Groundwater Transfer Review Summary Form

Transfer/PA # T- 14861

Application: T-14861

Applicant Name: Jenck Farms, LLC

Modeled Stream Depletion: Authorized POA TILL 50225/50440 to Trask River

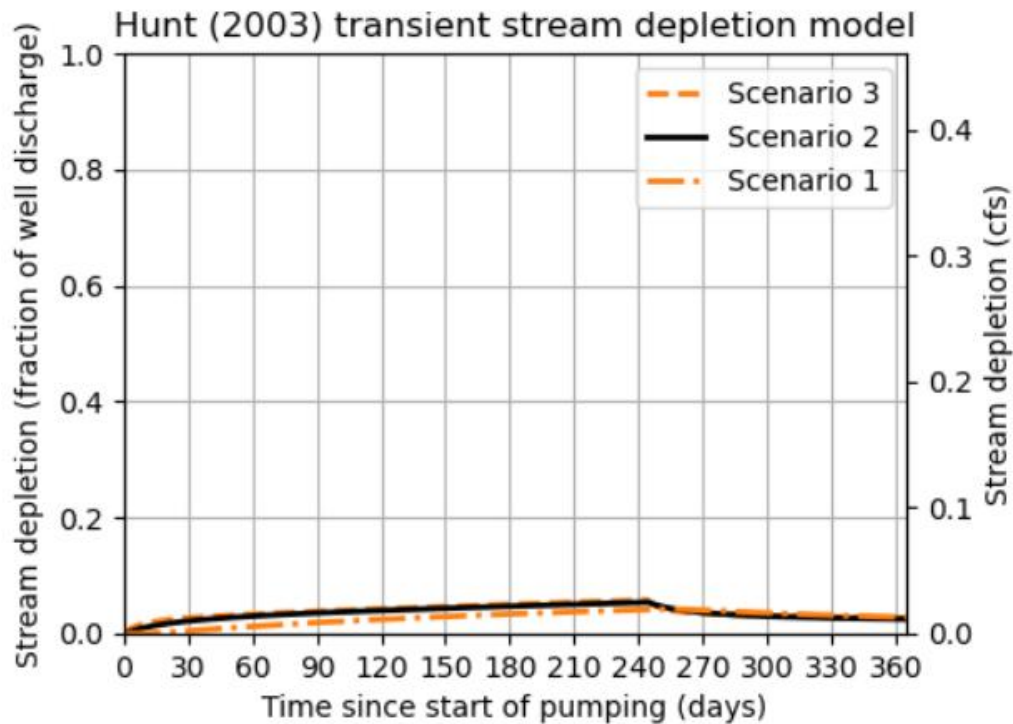
- b) If yes, at its maximum allowed rate of use, what is the expected change in degree of interference with any **surface water sources** resulting from the proposed change?
Stream: Trask River Minimal Significant
Stream: _____ Minimal Significant
Provide context for minimal/significant impact: The Hunt 2003 analytical stream depletion model was used to estimate the maximum potential interference at Trask River caused by the proposed change. Model parameters are derived from nearby pumping tests and published values (Freeze and Cherry, 1979). Model results indicate that interference is expected to increase by 1 to 2%. Based on the relatively efficient hydraulic connection and tidal influence on streamflow, the potential increase of interference with surface water sources is considered minimal.
